Addendum No. 1

College of Southern Idaho Leroy Craig Center

ADDENDUM NO. 1
January 16, 2025

**PROJECT: LeRoy Craig Jerome Center
College of Southern Idaho
Jerome, Idaho**

SK-1

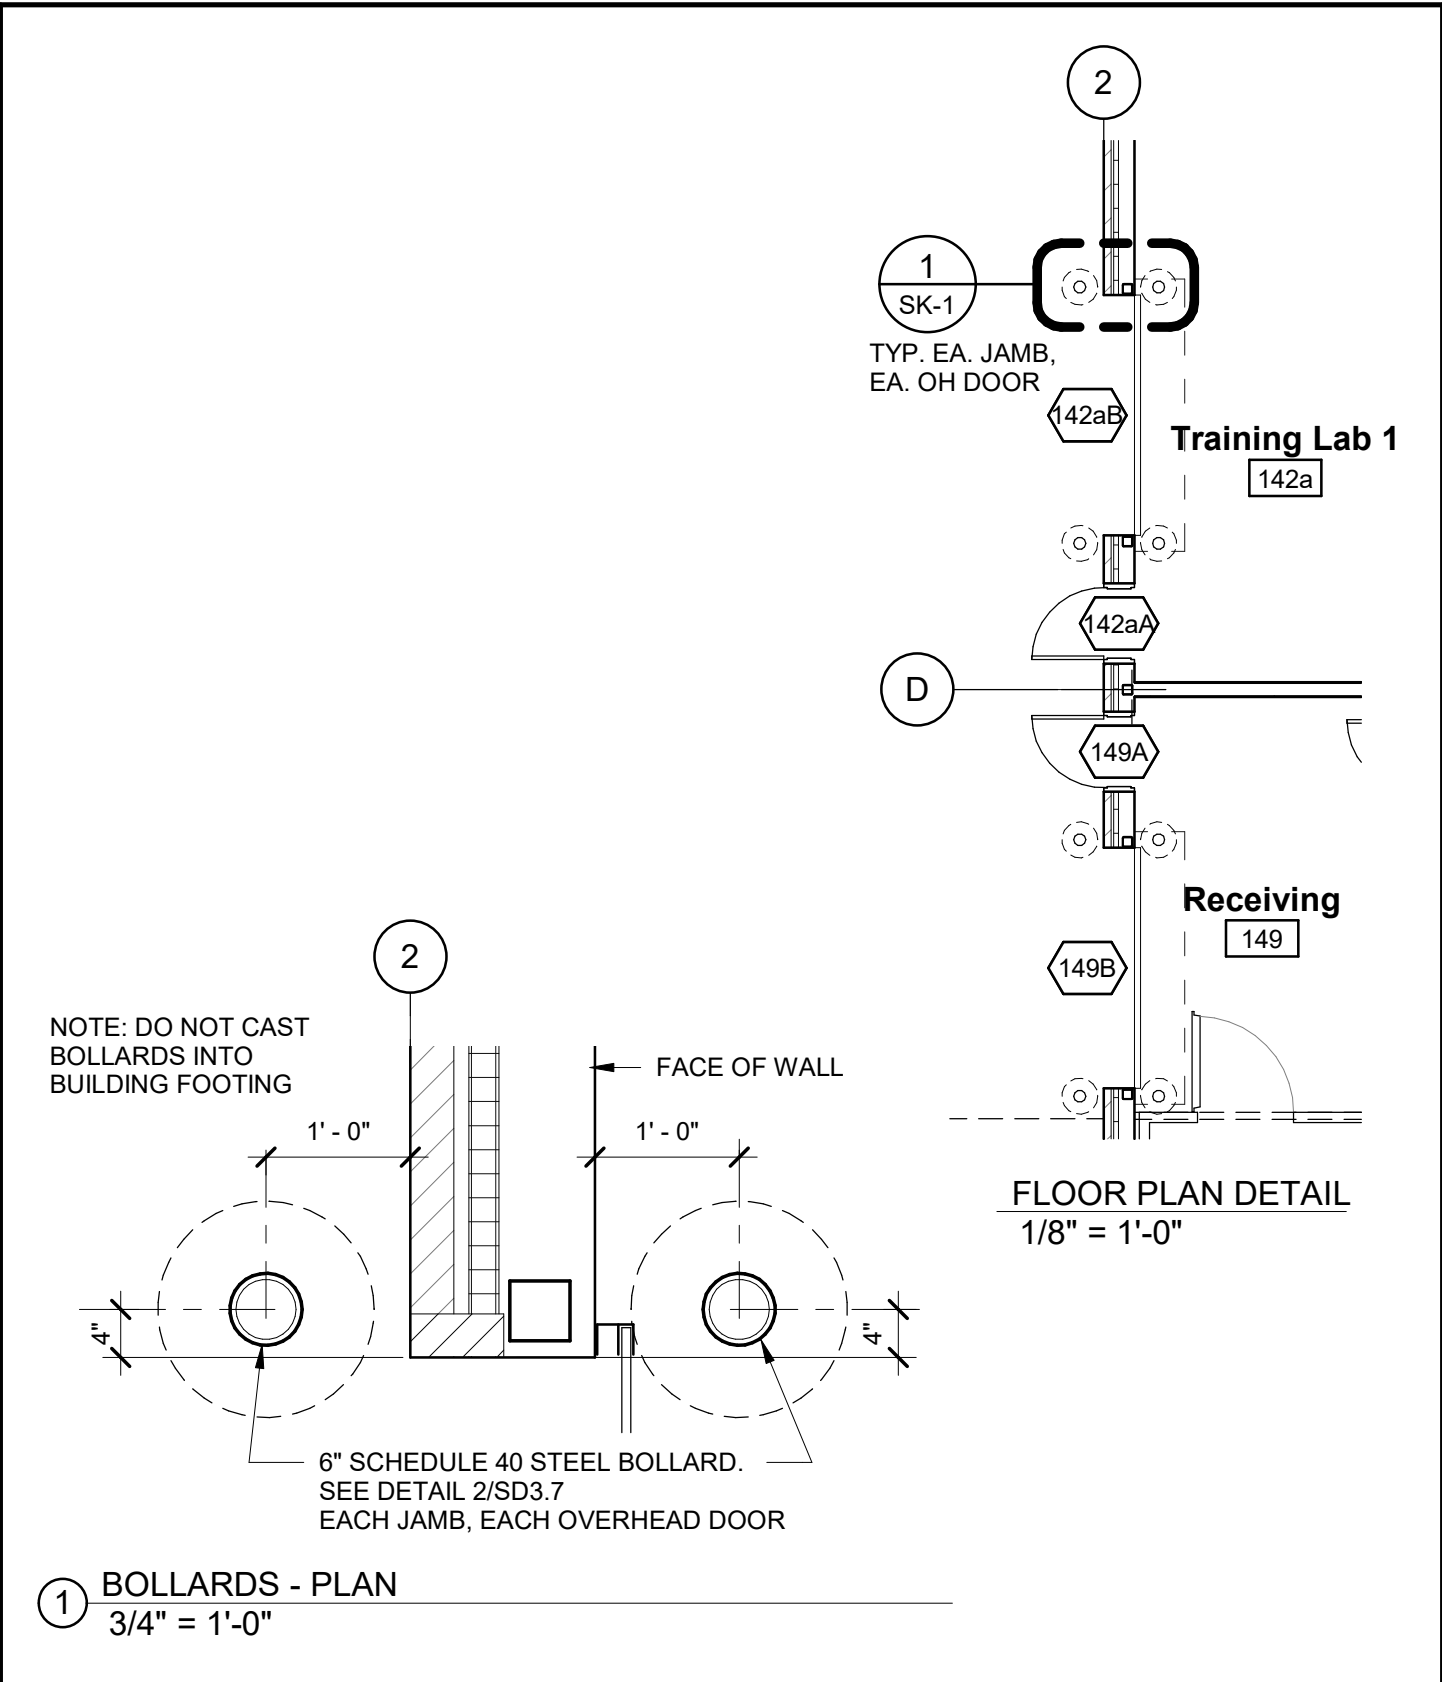
1. Add eight (8) 6" steel bollards at coiling overhead doors 142aB and 149B at exterior and interior jamb location both sides of opening. See Sketch SK-1.

DRAWING NO.:
P1.0
PLUMBING FOUNDATION
PLAN

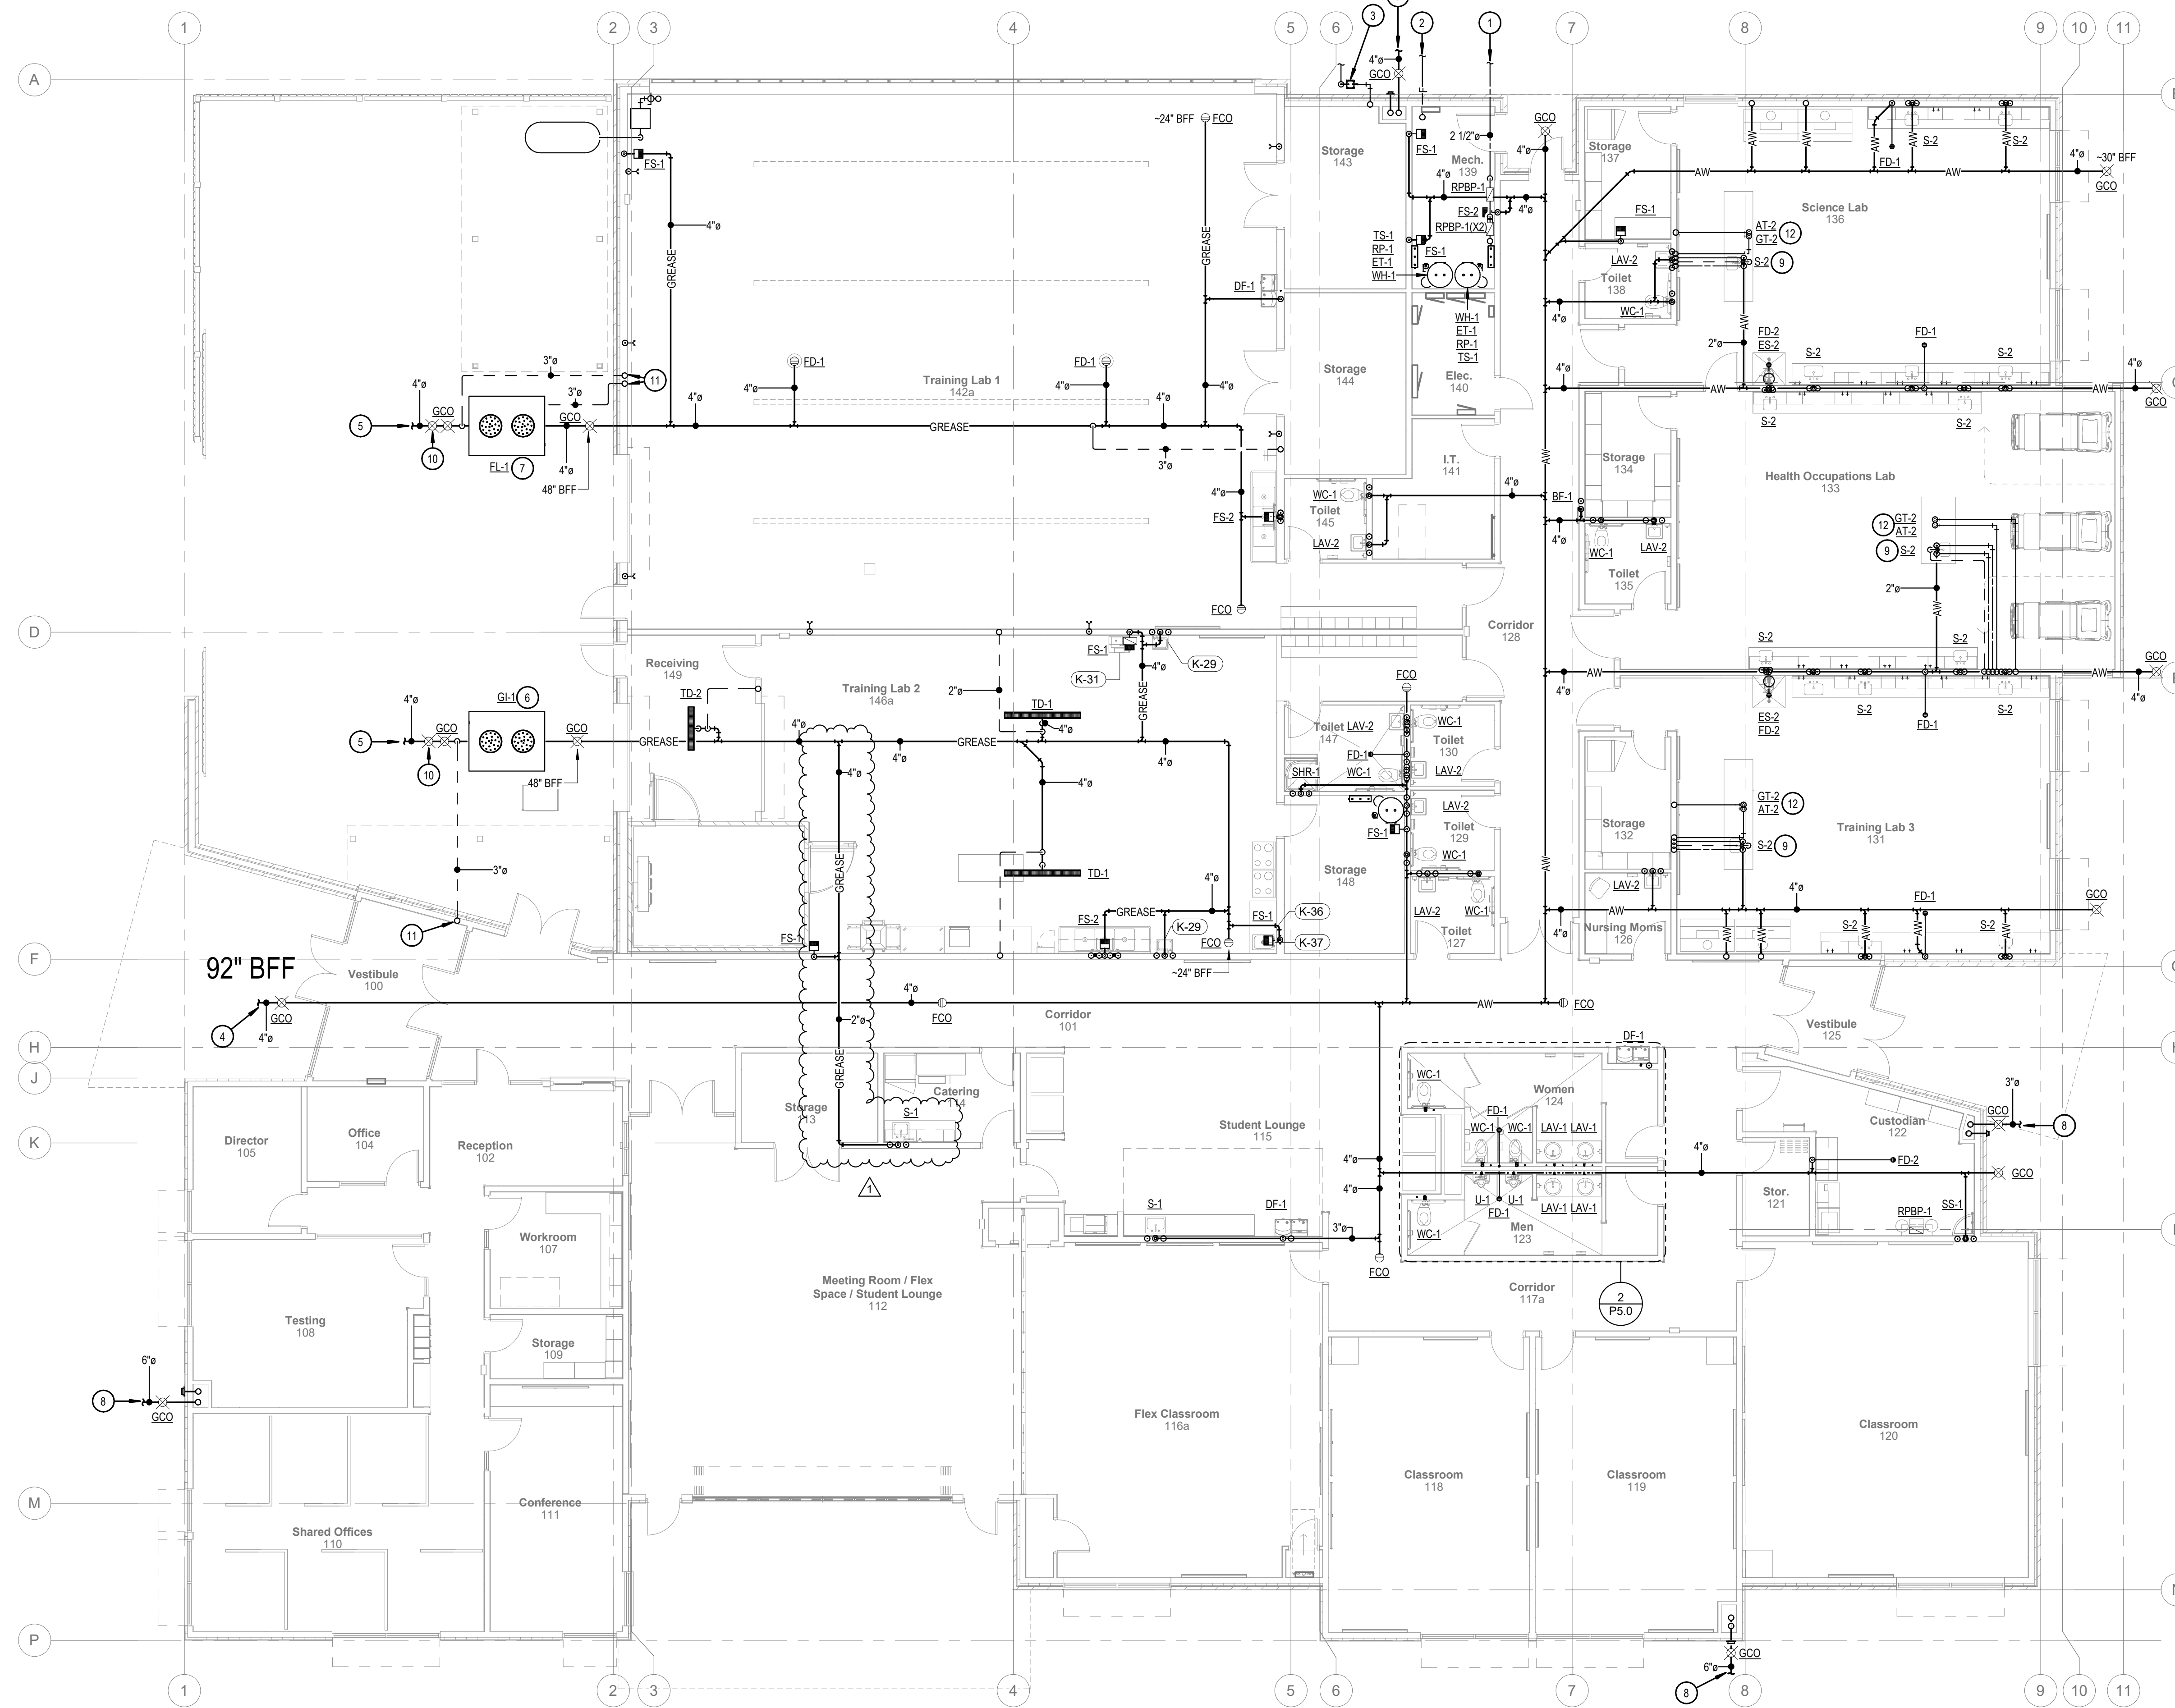
1. Sheet P1.0 – Plumbing Foundation Plan
 - a. Waste connection for sink in catering 114 rerouted and connected to grease interceptor per city comments.
